# **IEEE P802.3bp (1000BASE-T1) PHY Task Force Channel Definitions Ad Hoc Report**

**San Antonio, Texas  
November 2014**

# Draft 1.0 comments – 97.4.4.1.4 Differential to common mode conversion

# Conversion Loss – proposal

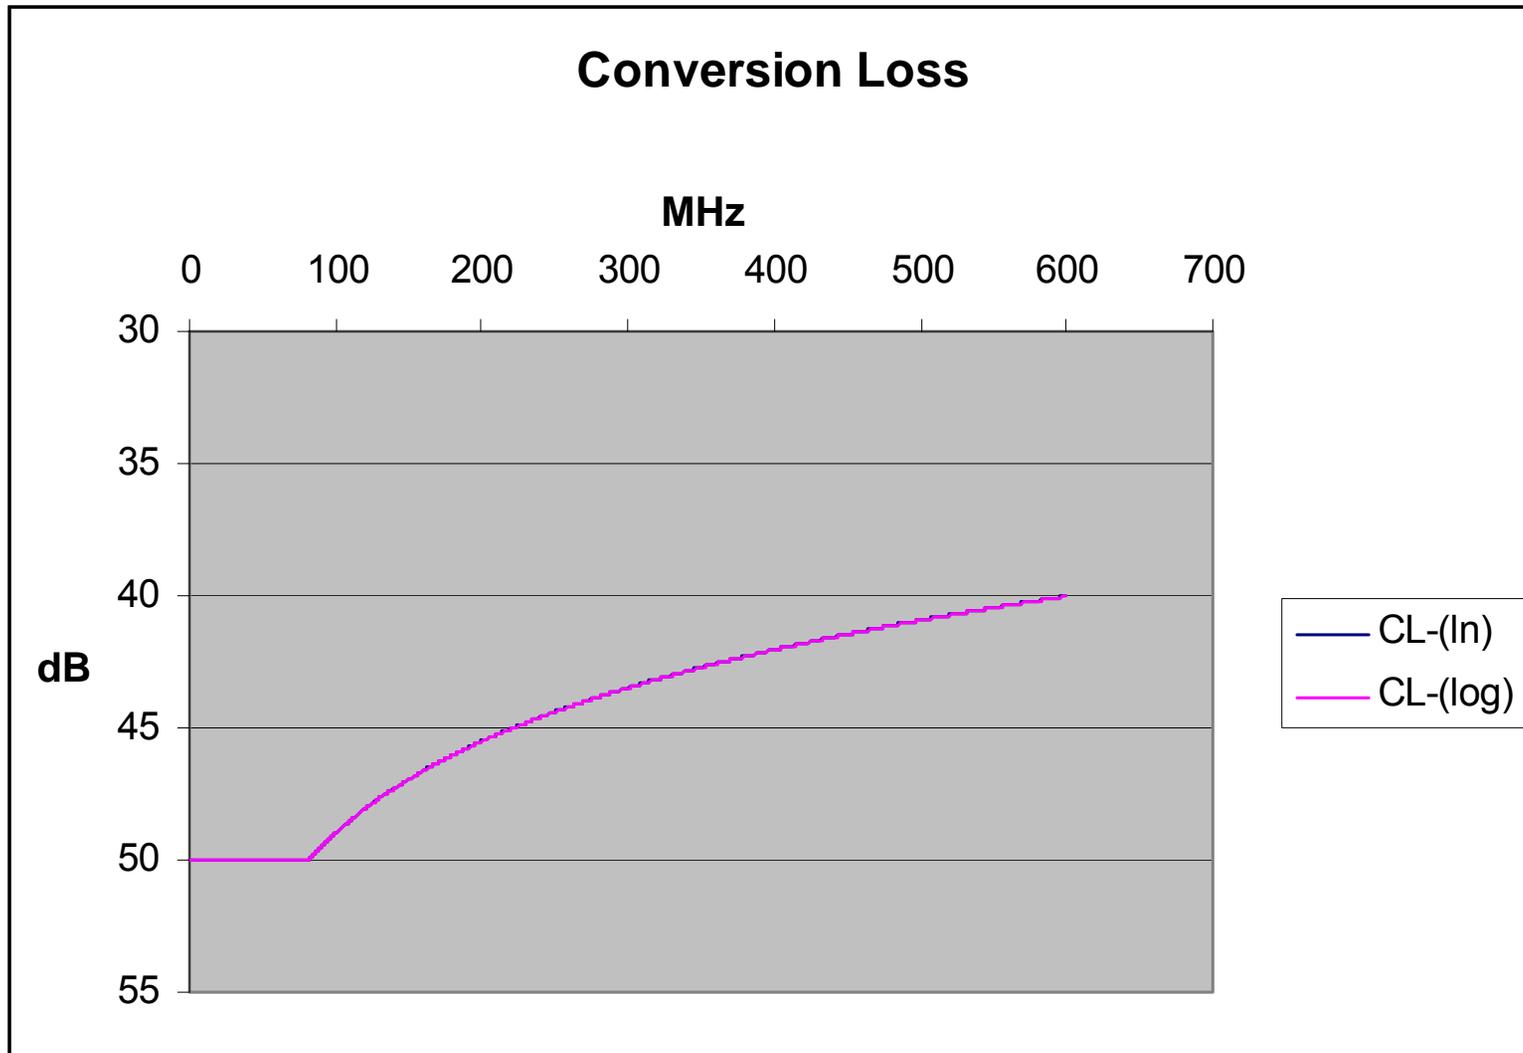
**Cl 97**      **SC 97.4.4.1.4**                      **P 28**                      **L 24**                      # **51**  
 DIMinico, Christopher                      MC Communications  
**Comment Type**    **T**                      **Comment Status**    **D**                      **Equation (97-3)**  
 change equation 97-3 to use log10 and yield positive values (loss).  
**SuggestedRemedy**  
 Change equation 97-3 to ConversionLoss  $\geq [50 - 10 \log_{10}(f - 80)]$  dB  $[72 - 11.51 \log_{10}(f - 80) - 600]$  dB where f is frequency in MHz.  
**Proposed Response**                      **Response Status**    **W**  
 PROPOSED ACCEPT IN PRINCIPLE.  
 Needs alignment with comment #27

**Cl 97**      **SC 4.4.1.4**                      **P 28**                      **L 26**                      # **27**  
 Chini, Ahmad                      Broadcom  
**Comment Type**    **ER**                      **Comment Status**    **D**                      **Equation (97-3)**  
 Equation (97-3) needs to be corrected for loss instead of gain. Replace "ln" with equivalent log10 to be consistent with other equations as well.  
**SuggestedRemedy**  
 Use the equation in the attached document.  
**Proposed Response**                      **Response Status**    **W**  
 PROPOSED ACCEPT IN PRINCIPLE.  
 Reference: chini\_3hp\_01\_1114.pdf - needs alignment with comment #50

*Editorial Note (to be removed prior to publication): Equation (97-3) needs to be converted into conversion loss.*

Correction: 
$$\text{ConversionLoss}(f) \geq \begin{pmatrix} 50 & 10 \leq f \leq 80 \\ 72 - 5 \ln(f) & 80 < f \leq 600 \end{pmatrix} \text{ dB}$$

Recommendation: → convert *ln* to *log* to be consistent with all other equations

$$\text{ConversionLoss}(f) \geq \begin{cases} 50 \text{ dB} & \text{for } 10\text{MHz} \leq f < 80\text{MHz} \\ 72 - 11.53 \times \log_{10}(f) \text{ dB} & \text{for } 80\text{MHz} \leq f \leq 600\text{MHz} \end{cases}$$

$$5 \cdot \ln(f) = 5 \cdot \ln(10) \cdot \log(f) = 11.51 \cdot \log(f)$$

→ resulting equation: 
$$\text{ConversionLoss}(f) \geq \begin{pmatrix} 50 & 10 \leq f \leq 80 \\ 72 - 11.51 \cdot \log(f) & 80 < f \leq 600 \end{pmatrix} \text{ dB}$$
